Project No. 25-0056.00 October 17, 2025

ADDENDUM NO. 3
TO THE
DRAWINGS AND PROJECT MANUAL
FOR
NORTH SHORE MULTI-USE INDOOR FACILITY
GALENA PARK INDEPENDENT SCHOOL DISTRICT
HOUSTON, TEXAS

10/17/2025

SHEET NO.
S1.03

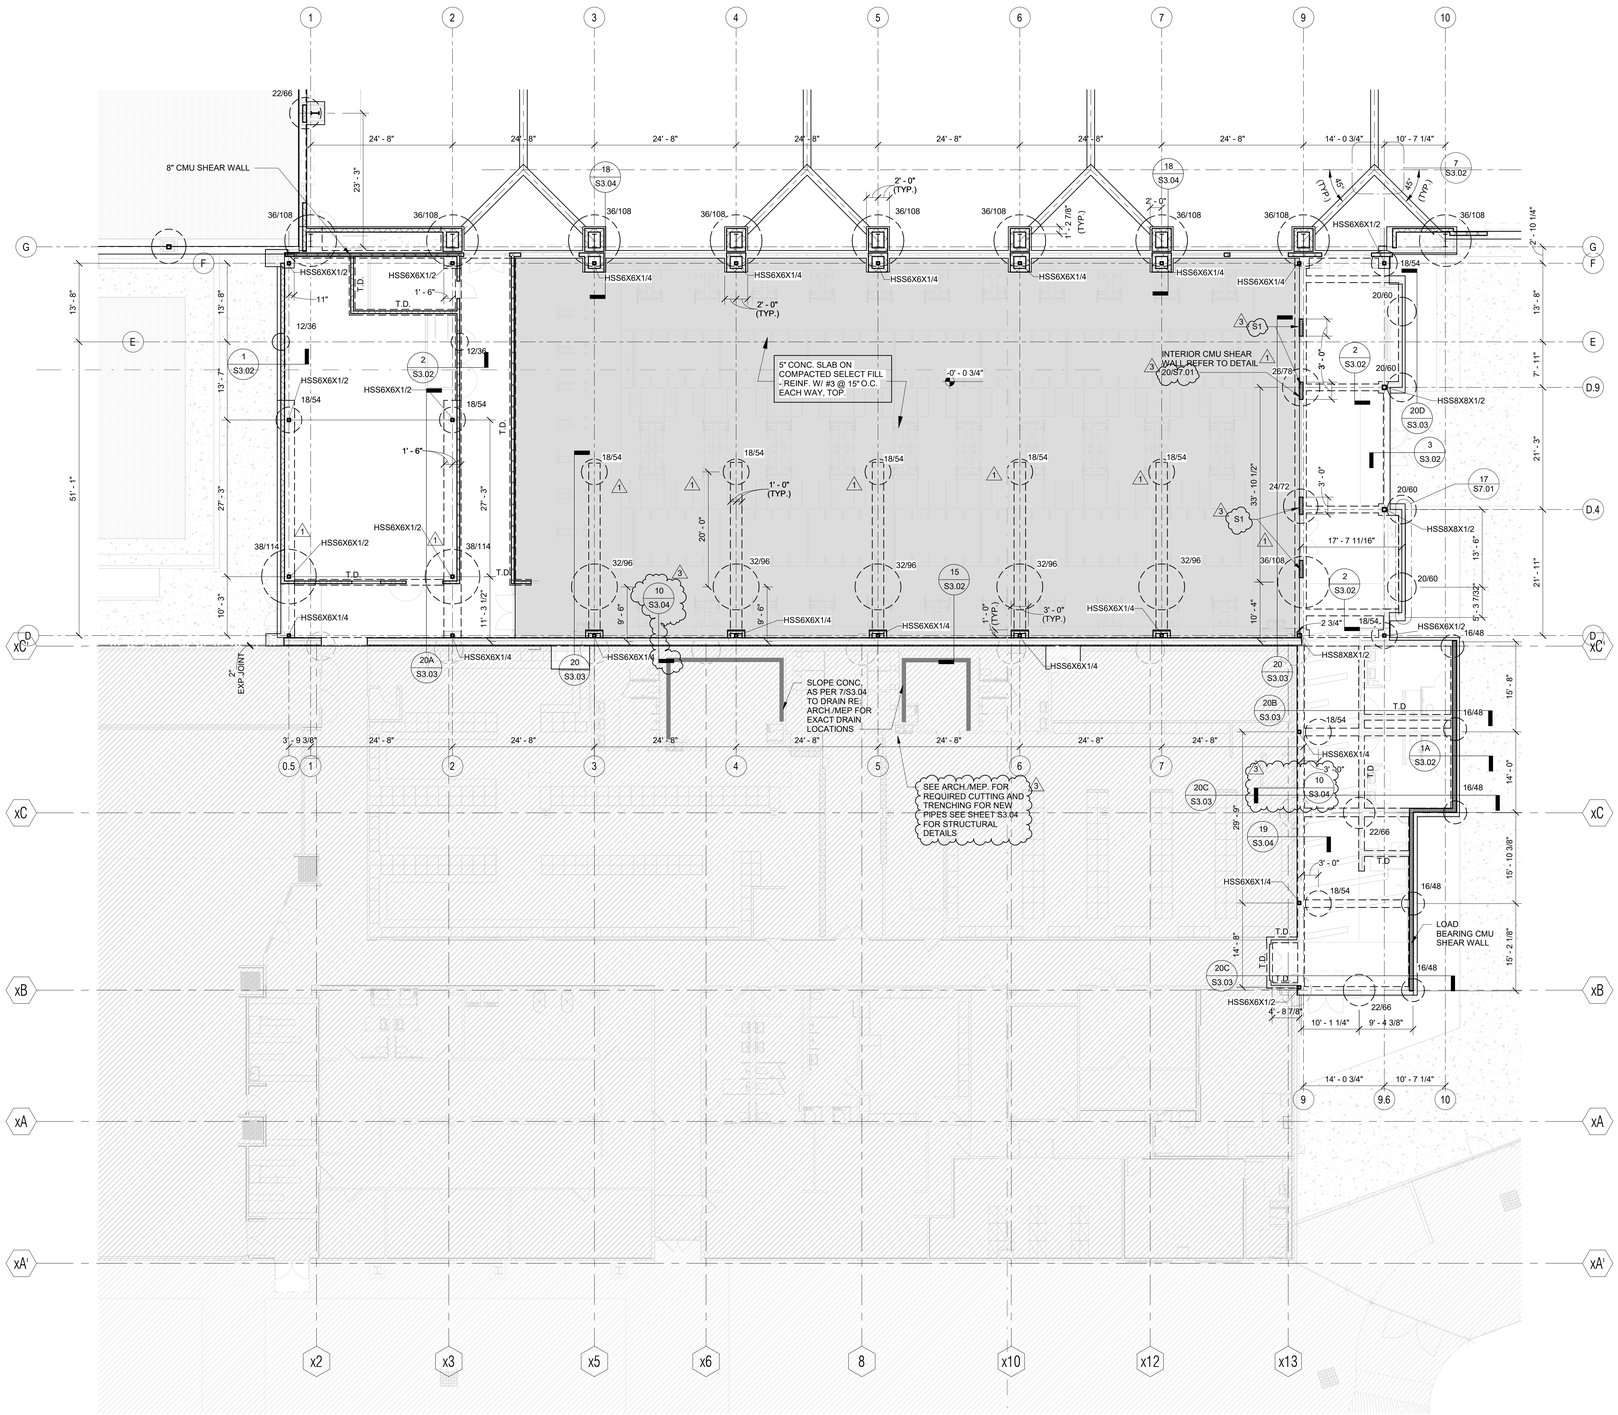
1. SHEET S1.03– 3D – VIEW

SHEET NO.
S2.01B

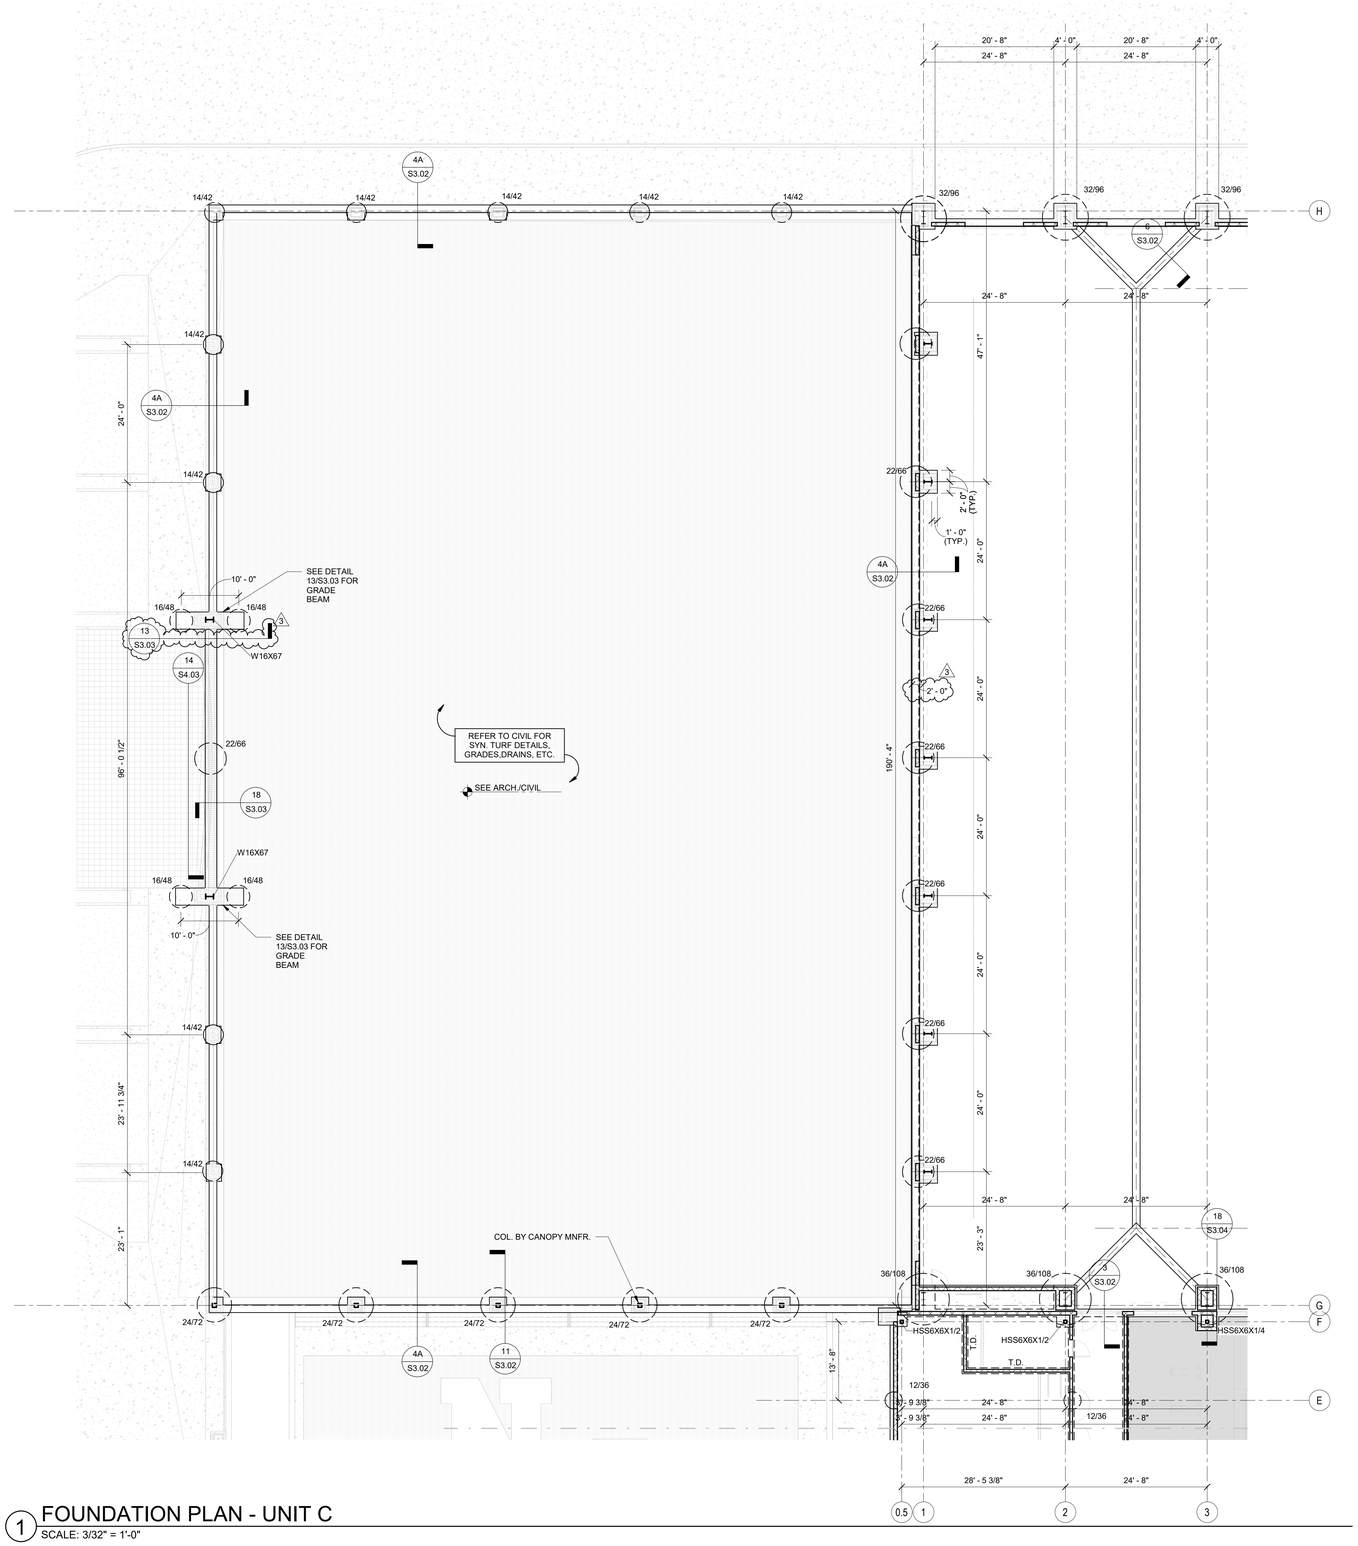
2. SHEET S2.01B – FOUNDATION PLAN UNIT – B

C. Section cut of detail 10/S3.04 added on gridline D & gridline 9

SHEET TITLE
FOUNDATION PLAN - UNIT C

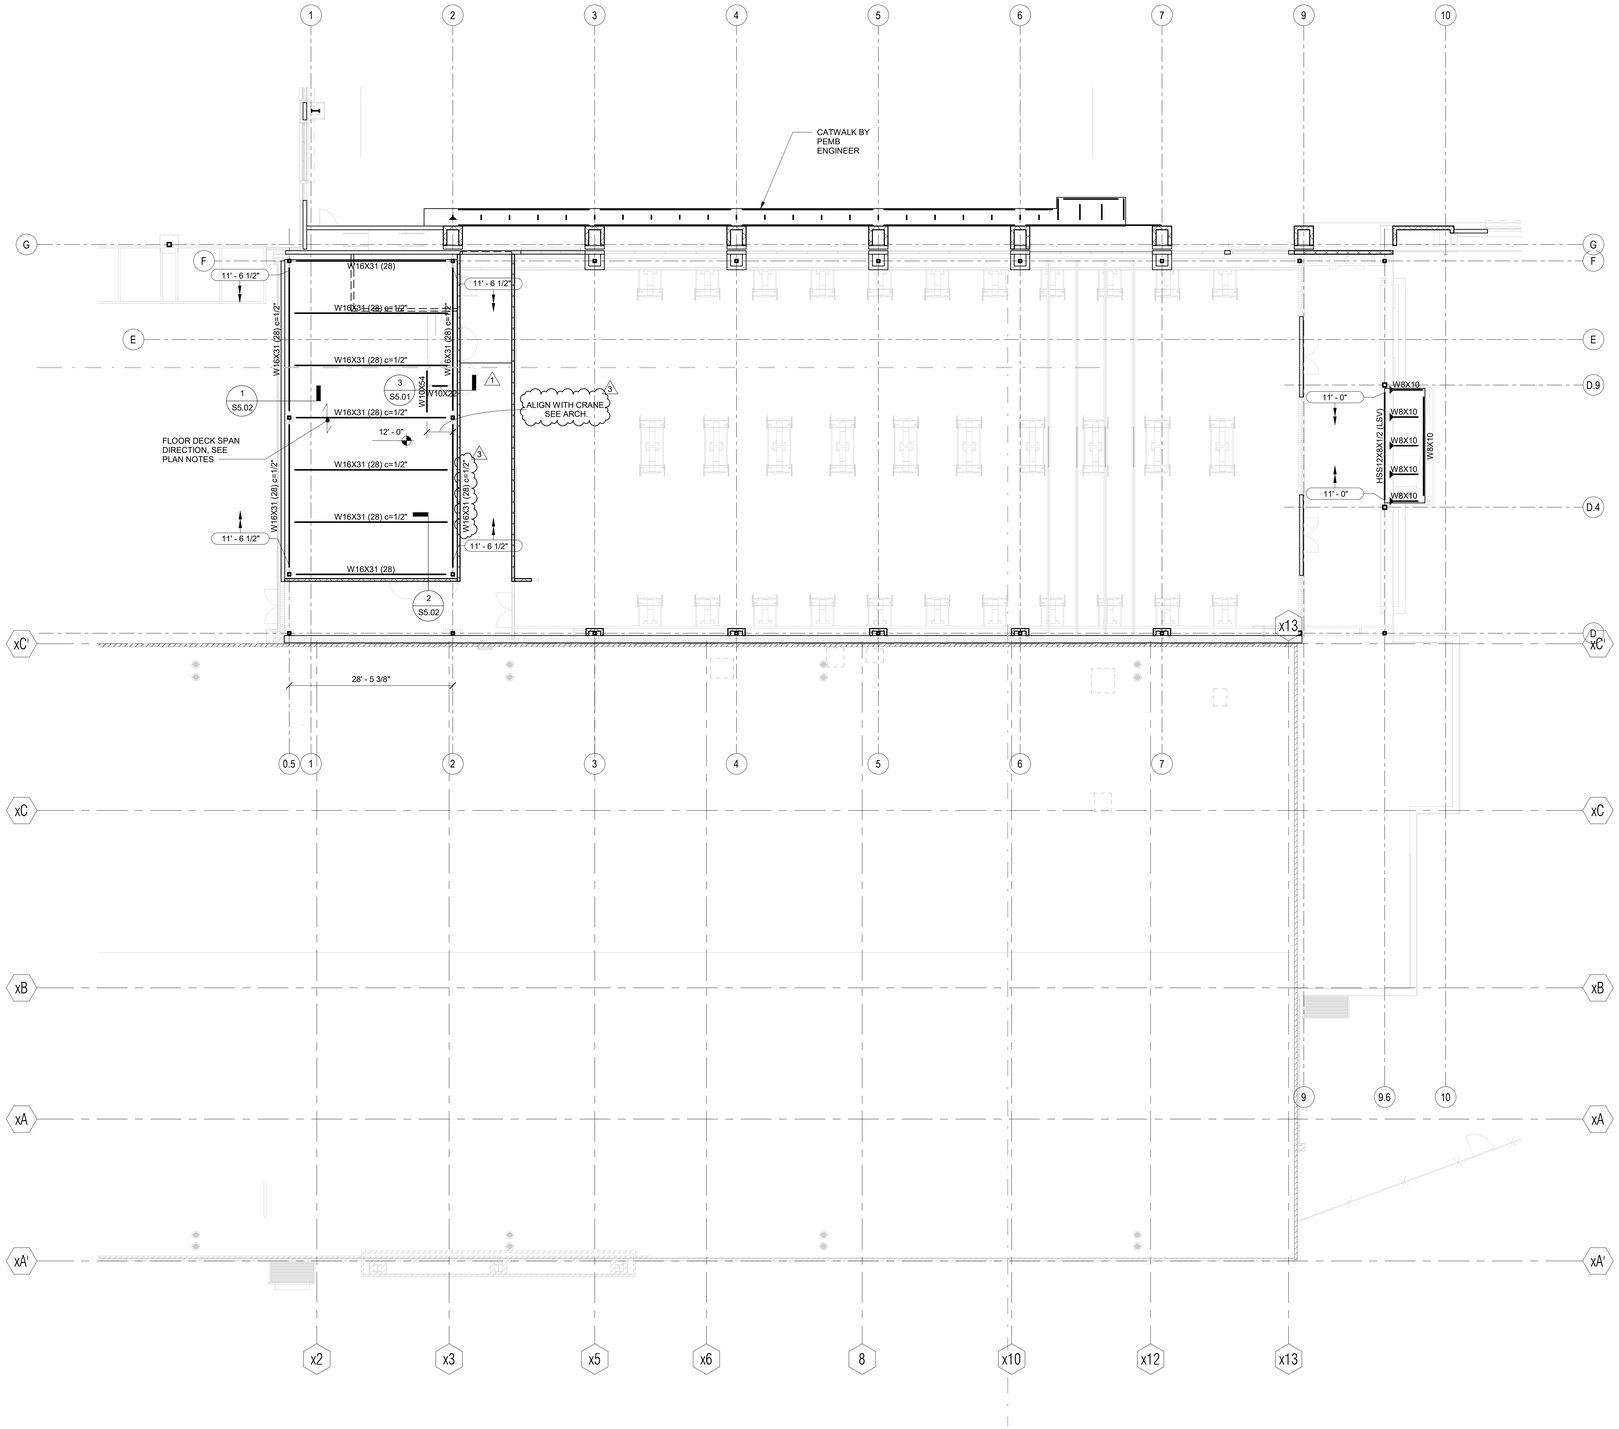
3. SHEET S2.02C – FOUNDATION PLAN - UNIT C
